SERVICE LETTER 227

10000A Floats Inline Filters Replacement

Aircraft Makes/Model(s):	Float Model(s):	Compliance: Optional	By: MAB
Air Tractor AT-802 & AT-802A	10000A	Part Number: 1011841	Approved: SDW
		Date: 4/23/2021	Revision: A

1003665 ACCUMULATOR ASSEMBLY

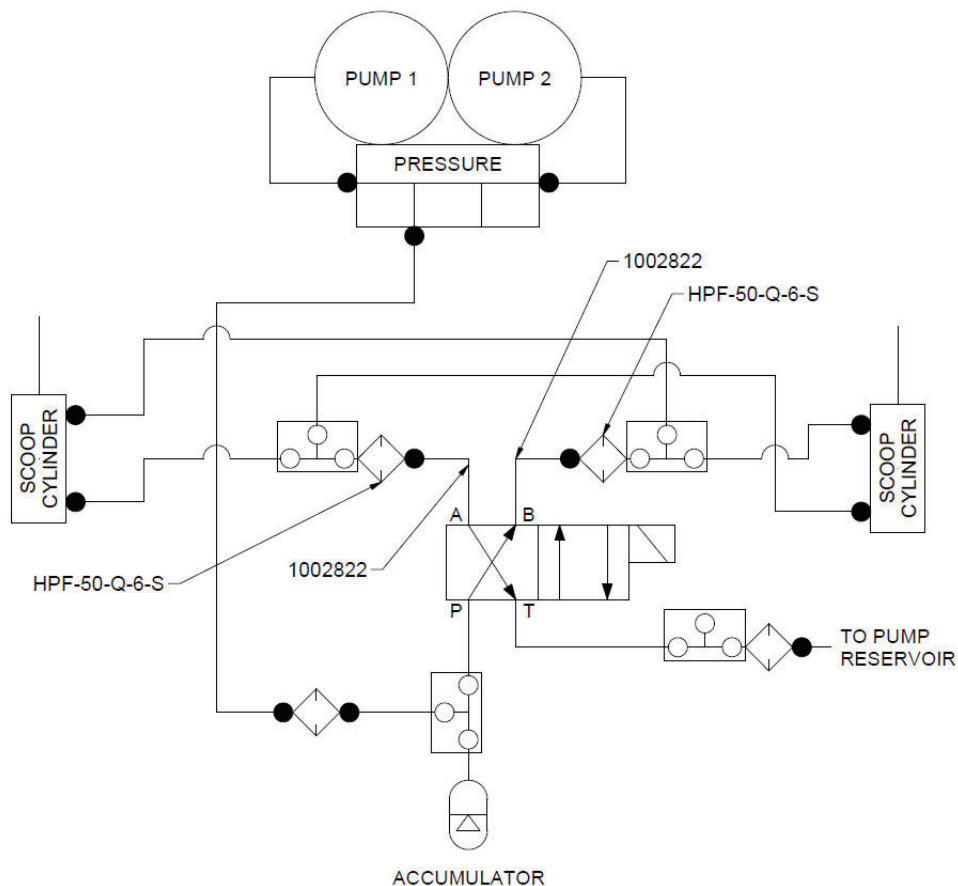
When hydraulic fluid is returned from the scoop cylinders, it is causing the filter element to chatter against the internal o-ring. The o-ring can fail causing small pieces of o-ring to flow out of the inline filter and into the directional valve. This service letter provides installation instructions to replace the two inline filters from the scoops to the directional valve with bi-directional inline filters.

4. Unbolt cushion clamps holding inline filters to accumulator assembly.
5. Remove both up and down hydraulic hard line assembly 1002822 from directional valve, ports "A" and "B."

6. Install new fittings into inline filter HPF-50-Q-6-S per image. Use thread sealant with all pipe threads.
7. Install inline filter HPF-50-Q-6-S onto new hydraulic hard line assembly 1002822.

8. Install new hydraulic hard line assemblies onto directional valve manifold fittings, ports "A" and "B."
9. Install MS21919WDG23 cushioned clamps onto inline filters and mount to accumulator plate using supplied hardware.
